CALIFORNIA COASTAL COMMISSION

Addendum

Subject: Addendum to **Item W16b**, Coastal Commission Permit Application
#6-13-0948 (Bannasch), for the Commission Meeting of May 14, 2014

(tape measure measuring 64" in 2001)

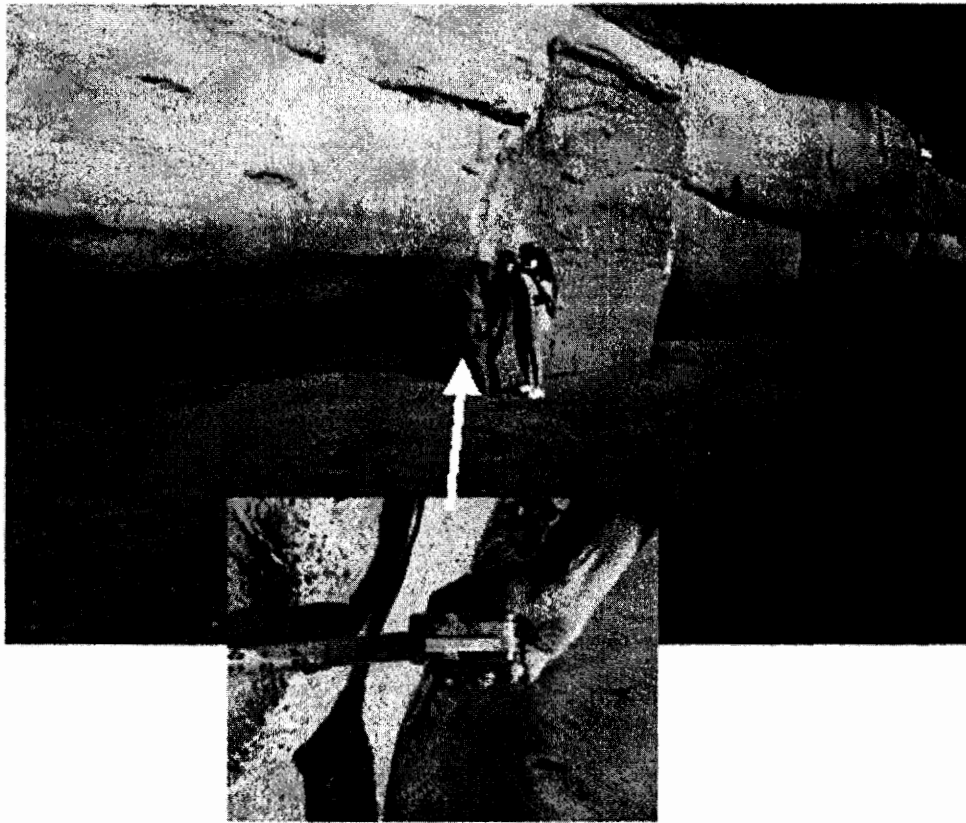
It is anticipated that to maintain the integrity of the existing seawall, adjacent fill will have to be replaced even if the erosion rate of the new fill matches that of the existing bluff, thereby negating its effectiveness as erodible mix and making the entire structure function as a seawall.

In the picture below of the existing wall from 2001, it was flanked at least 64" at the surface indicating the existing fill did not erode at the same rate as the bluff. The fill is in the same location today and erosion has persisted. In fact this means adjacent to the existing seawalls (aka seacave fill), the bluff is actually fixed at its 1991 location.

PROPOSED REMOVAL OF EXISTING INFILL "B"

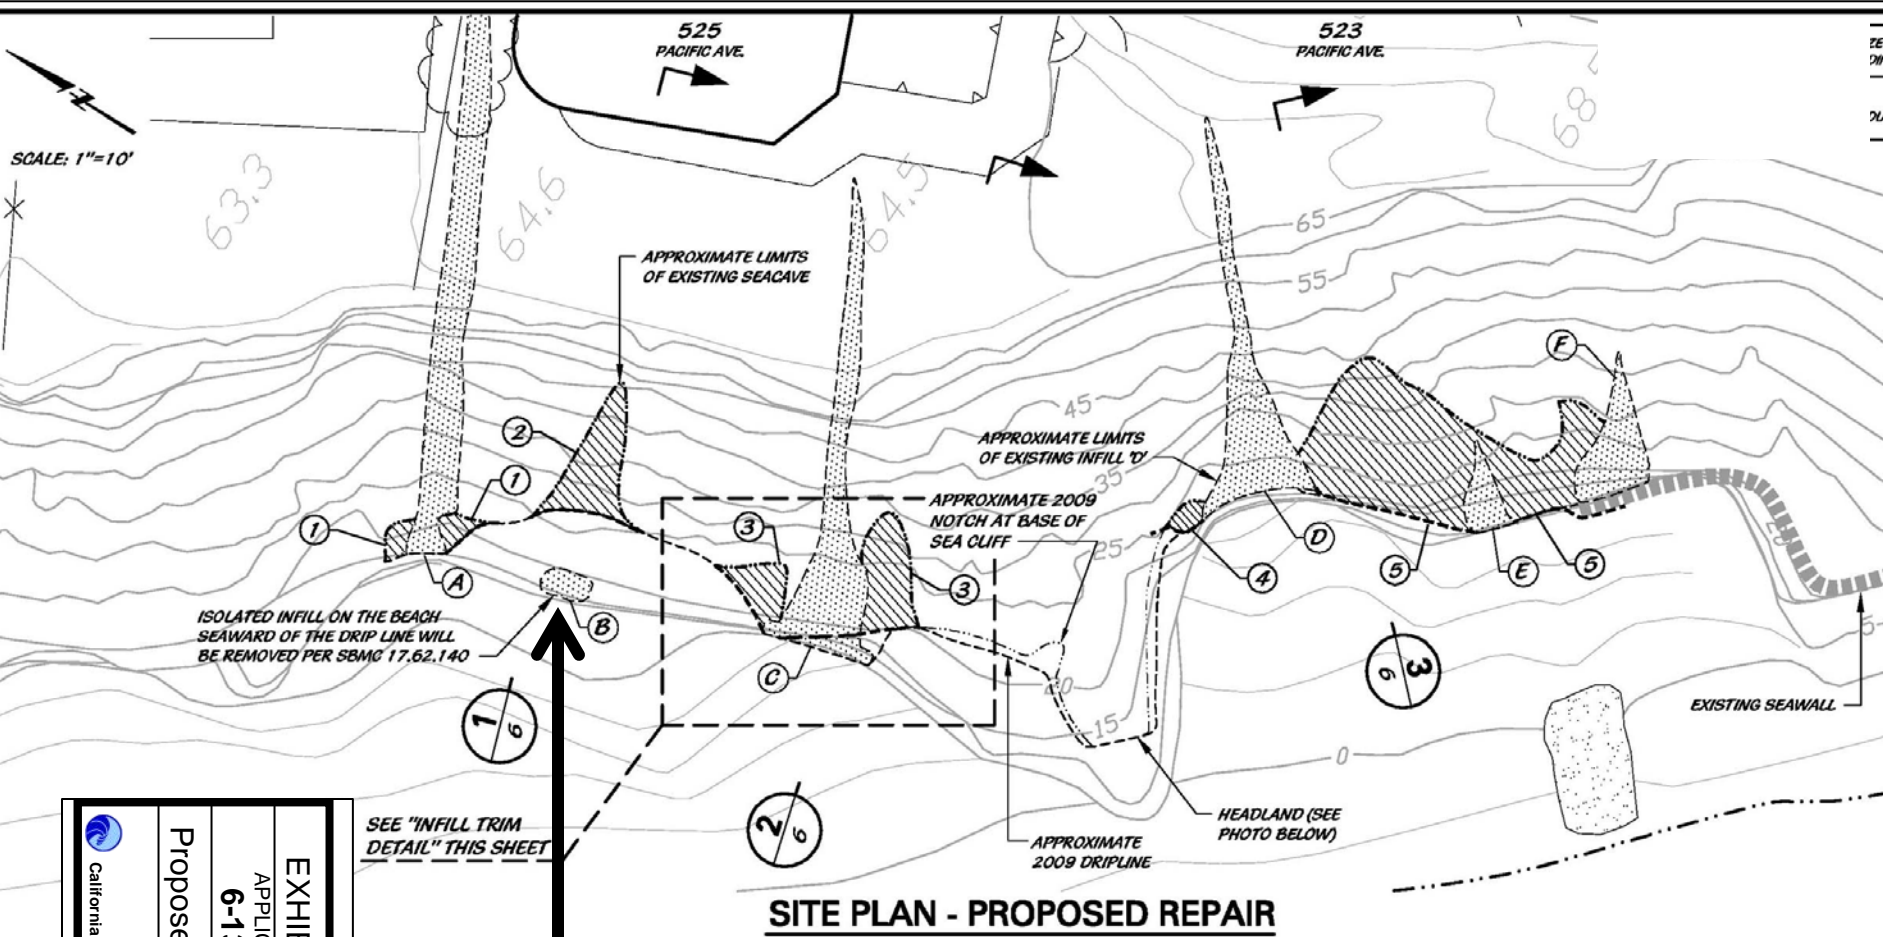
- e. The existing approximately 24 sq. ft. seacave infill located on the beach labeled “B” shall be removed (Exhibit 3) and the existing seacave infill labeled “C” shall be removed to the maximum extent possible without cutting into terrace deposits/clean sands (Exhibits 4-6). The permittee shall undertake the development in accordance with the approved plan. Any proposed changes to the approved plan shall be reported to the Executive Director. No changes to the

The applicant is proposing to remove existing seacave Infill "B," which is no longer connected to the bluff (Exhibit 3). Infill "B" currently covers approximately 24 sq. ft. of beach area. Removal of this infill will result in additional beach area for the public, although it should have been undertaken many years ago.

PROPOSED REMOVAL OF PORTION OF EXISTING INFILL "C"

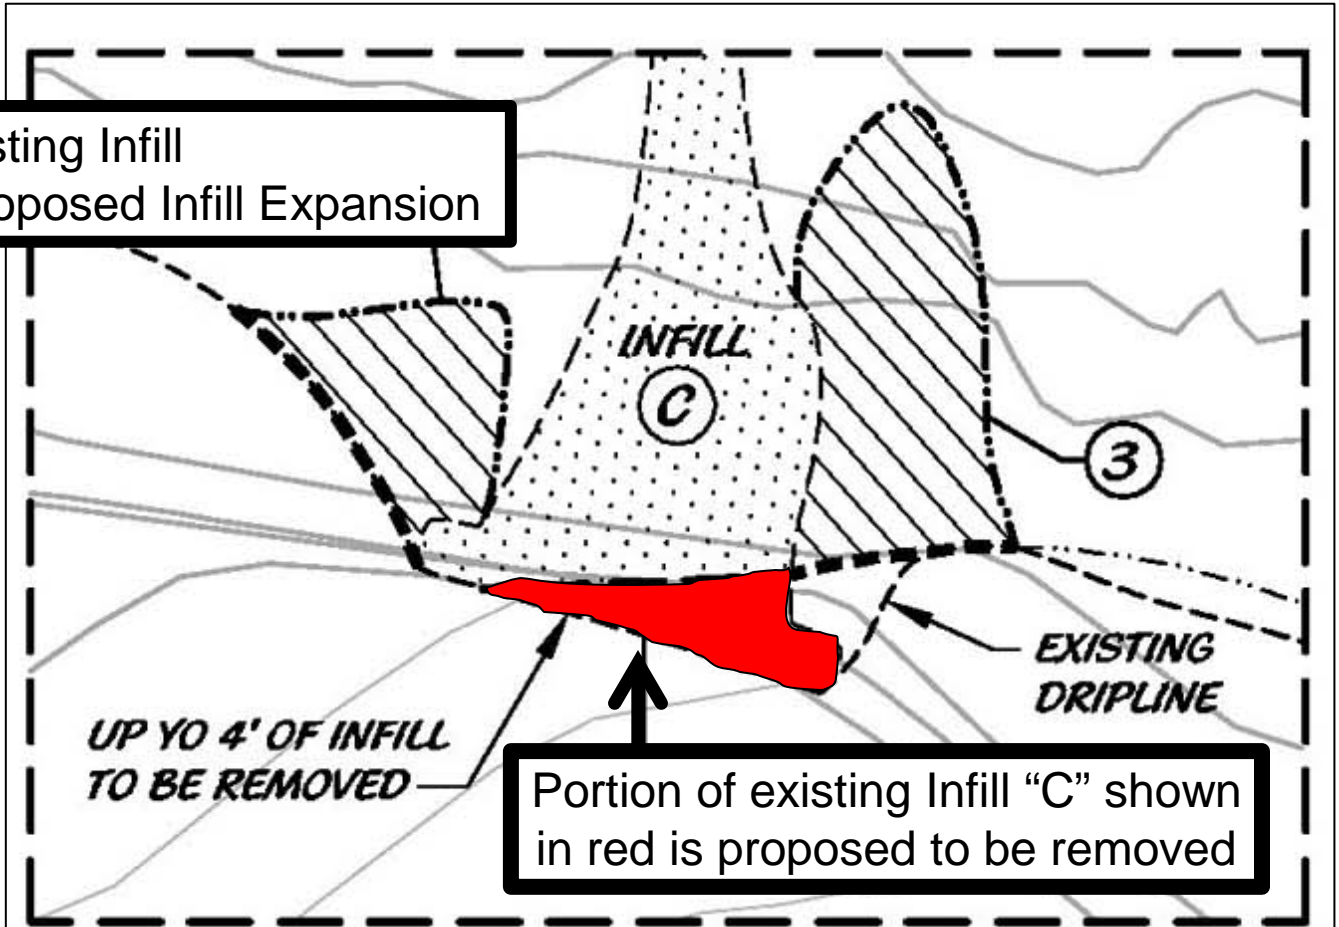
A portion of existing seacave Infill "C" is protruding approximately 7 ft. seaward of the adjacent bluff on either side (Exhibit 4-5). At medium and high tides, this protrusion has the potential to adversely impact lateral access along the shoreline, which will be exacerbated as the adjacent bluff continues to erode landward, if the protrusion is not removed. The applicant has proposed to remove approximately 25 sq. ft. of the portion of Infill "C" that encroaches on the public beach (Exhibit 6).

The entire portion of Infill "C" located seaward of the natural bluff should be removed. The intent of allowing the fill originally was to prevent large seacave collapses, while still allowing the bluff to retreat landward through the natural weathering process (Exhibit 12). Special conditions on the project specifically require that the applicant remove debris deposited on the beach as a result of the failure of the seacave infills or materials that become dislodged from the seacave infills through weathering and impair public access. Thus, it was clearly the understanding of the Commission when the CDP was approved that the seacave infills would result in portions of the seacave infills segmenting off the existing infill as they extend past the face of the bluff and the resulting debris would then need to be removed from the beach.

Portion of existing Infill "C" shown in red is proposed to be removed

site and concurs that complete removal of Infill “C” would result in the removal of some amount of terrace deposits/clean sands and could result in the destabilization of the coastal bluff. Therefore, Special Condition 1 requires that Infill “C” be removed to the maximum extent possible without cutting into terrace deposits/clean sands. Exhibit 6 has been prepared by the applicant to show the portion of Infill “C” that can be removed at this time. There is a chance that changes to the coastal bluff at the subject site may occur between Commission action on the subject CDP and final issuance of the subject CDP. Therefore, Special Condition 1 requires the applicant to submit final project plans prior to issuance of the CDP, prepared by an appropriately licensed professional and subject to the review and approval of the Executive Director, demonstrating that the maximum portion of Infill “C” that can be removed without cutting into terrace deposits/clean sands.
